Washington State
Department of Transportation

MEMORANDUM

SUBJECT: SR 543, OL-3500
Geotechnical Report Addendum No. 2
SR 5 to International Boundary Modifications

Figure E-1

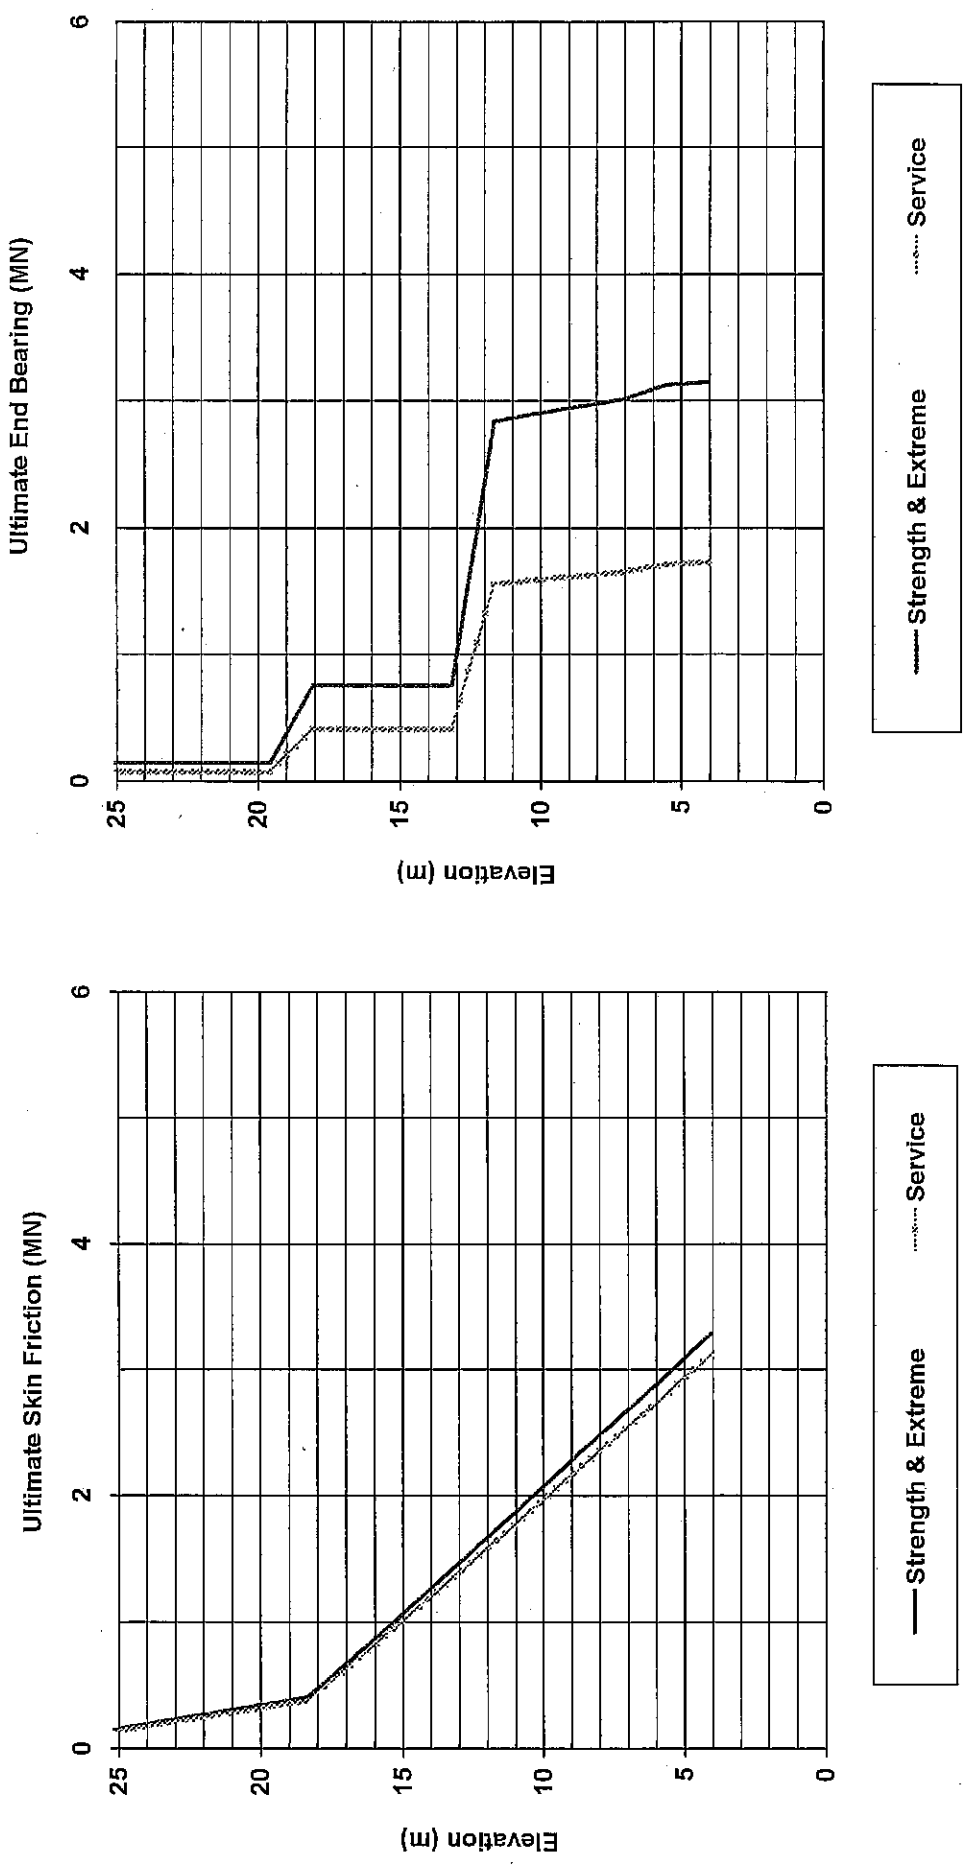
He also informed us that the drilled shafts supporting the Bridge at D Street were going to be reduced in size from 4 to 3 feet to save costs. This would require new axial capacity charts for the design of the new, smaller shafts.

Tangent pile walls will be used to support the proposed roadway cuts and bridges at the D Street intersection. At this intersection, the tangent piles should be designed as drilled shafts. We understand that the size of the drilled shafts at this location is being reduced from 1.22 meters (4 feet) to 0.91 meters (3 feet). We understand design of the proposed bridges at the intersection of SR 543 and D Street will be performed using AASHTO Load and Resistance

Factor Design (LRFD) methodology. In accordance with this methodology, we have provided axial capacities for nominal strength (ultimate), service and extreme limit states for the smaller drilled shafts on the charts in Appendix A. Foundation support should only be considered for "structural" piles and not "lean concrete" piles. For these attached charts, we assume friction and bearing support only occur below the elevation of the roadway crossing under the proposed bridges, and not from the top of the wall. These charts include nominal capacities for end bearing and skin friction resistance for 0.91-meter (3-foot) diameter shafts. Shaft uplift capacity for the strength and extreme event limit cases can also be taken directly from the capacity charts, where the unit uplift resistance is taken as equal to the unit skin friction. Note that the capacity charts do not account for the net weight of the shafts, which should be added as a separate load when sizing the shafts (for both compression and uplift).

After appropriate factoring (see Table 2 above) of the service and extreme event limit states charts shown in Appendix A, 25 and 150 mm (1 inch and 6 inches) of settlement, respectively, are required to mobilize these ultimate nominal capacities. Minimum tip elevations should be determined using these capacity charts and the required loading for the appropriate design limit state.
